**UNITED STATES  
NUCLEAR REGULATORY COMMISSION**  
WASHINGTON, D.C. 20555-0001

**SUBJECT: COMANCHE PEAK NUCLEAR POWER PLANT, UNITS 1 AND 2 – SAFETY  
EVALUATION REGARDING IMPLEMENTATION OF MITIGATING  
STRATEGIES AND RELIABLE SPENT FUEL POOL INSTRUMENTATION  
RELATED TO ORDERS EA-12-049 AND EA-12-051 (CAC NOS. MF0860,  
MF0861, MF0862, AND MF0863)**

**COMANCHE PEAK NUCLEAR POWER PLANT, UNITS 1 AND 2**

**Figure 1 - Comanche Peak SFP Levels of Monitoring**

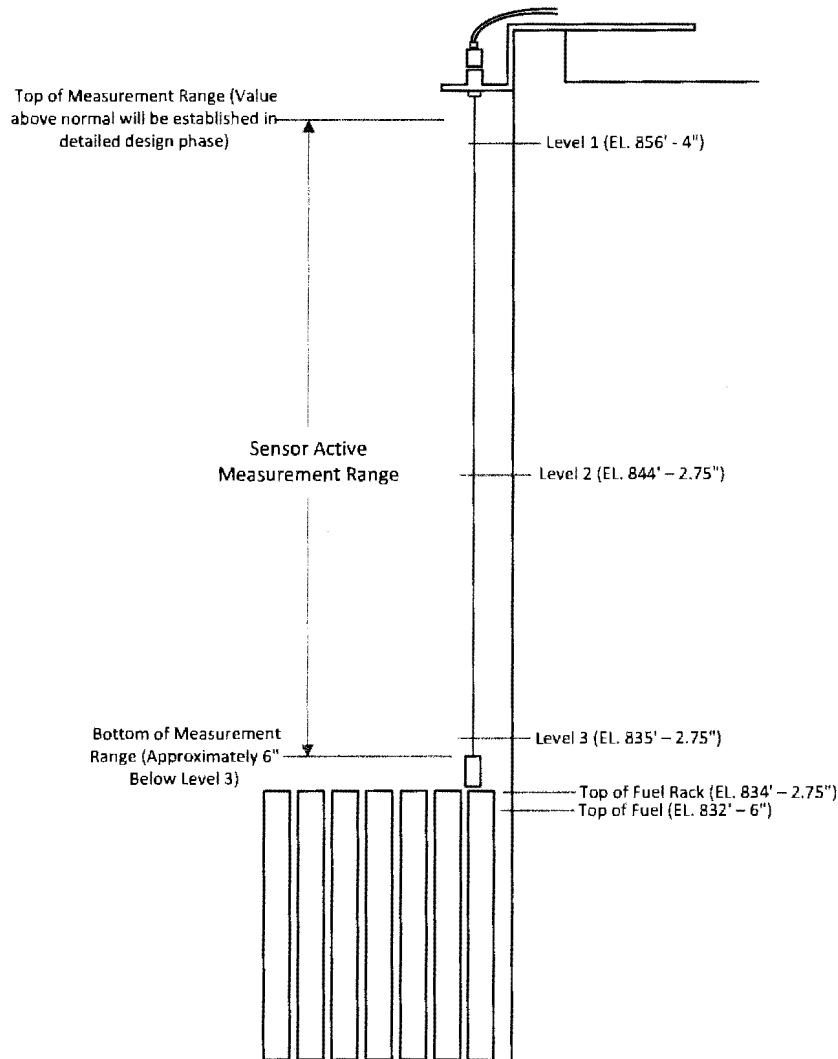
In its letter dated July 3, 2013 [Reference 24], the licensee stated that Comanche Peak designated Level 1 to be Elevation 856'-4" (22'-1.25" above the top of the fuel racks). This level corresponds to the LO-LO [low-low] level process setpoint that trips the fuel pool cooling pump as described in Comanche Peak UFSAR, Section 9.1.3.2. The LO-LO level process set point is selected to ensure that the pump will trip prior to a point where a void will occur in the suction lines. The licensee's analysis has demonstrated that there is adequate NPSH [net positive suction head] for pump operation at saturated conditions for water at plant elevation 856'. In its letter dated July 3, 2013 [Reference 24], the licensee also provided a sketch depicting Levels 1, 2, and 3 and SFP level measurement range as shown in the figure below (Figure 1 - Comanche Peak SFP Levels of Monitoring).

As discussed in NEI 12-02 [Reference 8], Section 2.3.1, Level 1 will be the HIGHER of two points. The first point is the water level at which suction loss occurs due to uncovering of the spent fuel cooling inlet pipe. The second point is the water level at which loss of spent fuel cooling pump NPSH occurs under saturated conditions. The NRC staff determines the designated Level 1 (856'-4") is the HIGHER of the above two points and therefore consistent with NEI 12-02 [Reference 8]. Level 2 was identified as elevation 844'-2.75". The NRC staff has determined this level is consistent with NEI 12-02 [Reference 8], since it is 10' ( $\pm 1'$ ) above the highest point of any fuel rack seated in the SFP. Finally, the NRC staff found that Level 3 (835'-2.75") is consistent with NEI 12-02 [Reference 8] Level 3, since it is above the highest point of any fuel rack seated in the SFP.

As for the SFP level measurement range, the licensee stated that the primary and backup instrument channels will provide continuous level indication over a range of 23'-9.25", from 12" above the top of the fuel storage racks (plant elevation 835'-2.75") to the high pool level elevation (plant elevation 859'). In its letter dated July 3, 2013 [Reference 24], the licensee provided a sketch depicting the SFP levels of monitoring and the instrument measurement ranges (Figure 1 of this evaluation).
